Subject: West Pasco Class III Landfill, Permit Renewal Application
Responses to Request for Additional Information

GROUND WATER MONITORING PLAN EVALUATION (Rule 62-701.510(9)(b), F.A.C.)

REPAIR OF 4MW-7

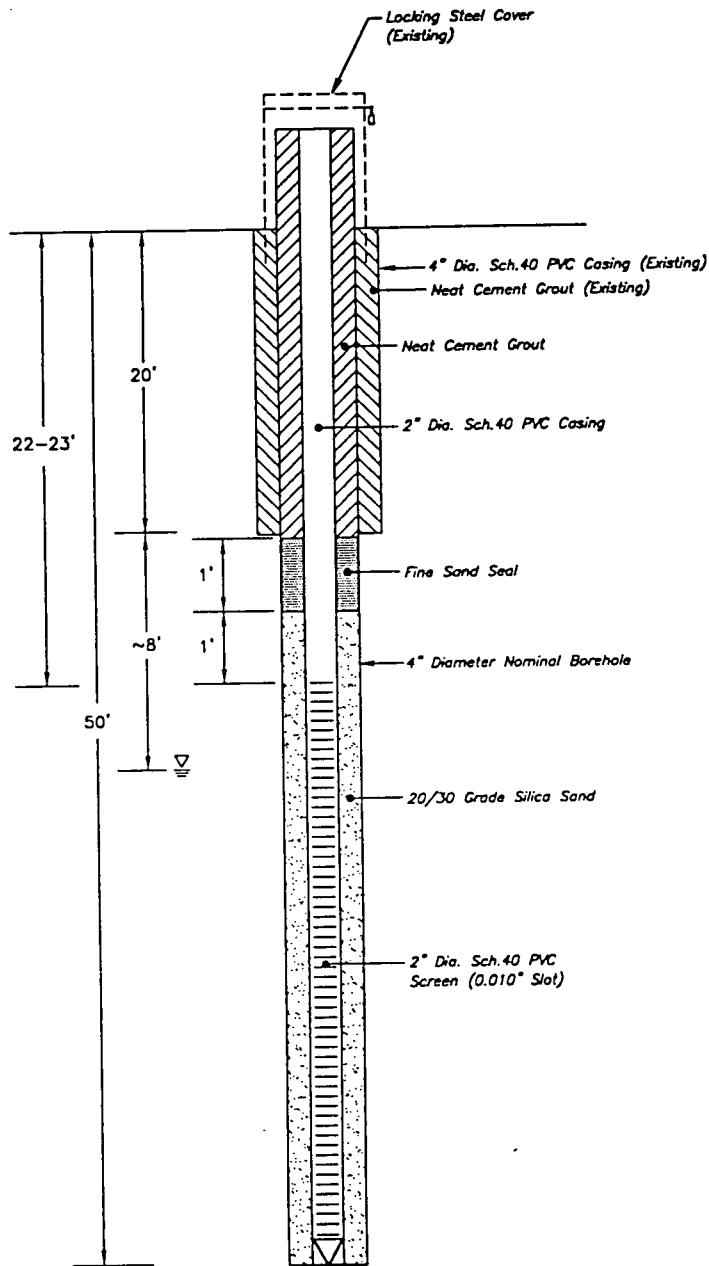
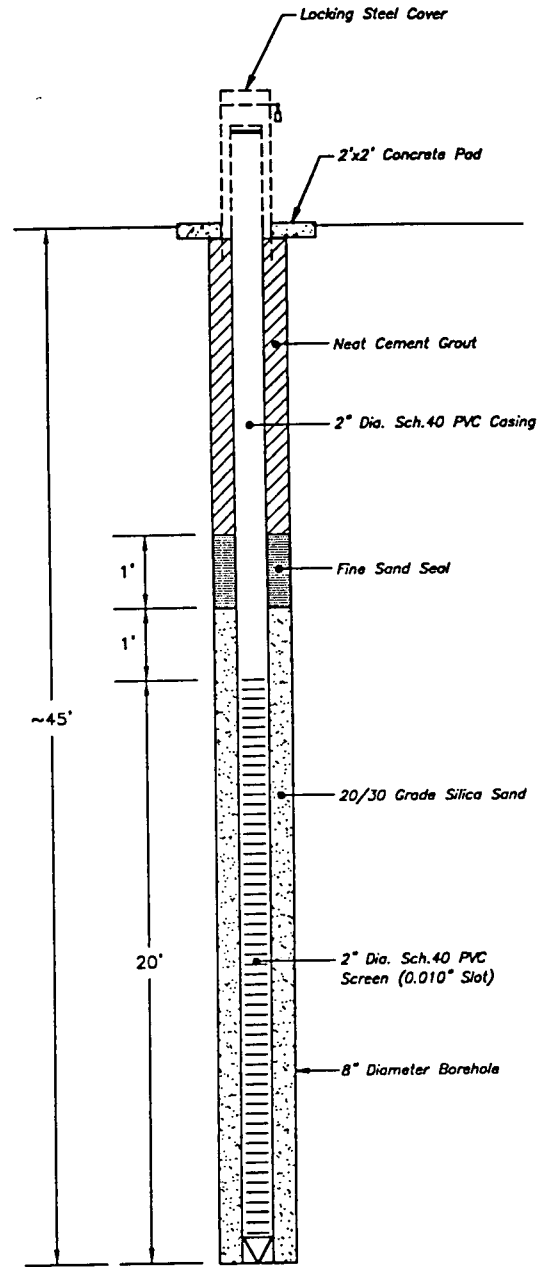
11. The proposed work plan to repair or replace well 4MW-7 submitted as Attachment 11 (QORE, Inc. dated July 9, 2001) appears to be incomplete. Please revise this work plan to include the proposed elevation of the well screen and provide the requested justification for the screen interval to meet the requirements of Rule 62-701.510(3)(d), F.A.C. Please include the information provided in the response to item No. 7 above, regarding the open hole interval elevations and ground water elevations recorded at well 4MW-7 when justifying the proposed screen elevations and screen length. Please note that the Department intends to maintain the well identification number in the event that the well can be repaired, but a new identification number shall be required if a replacement well is needed.

Response: Qore, Inc. will be addressing the Department's comment under separate cover.
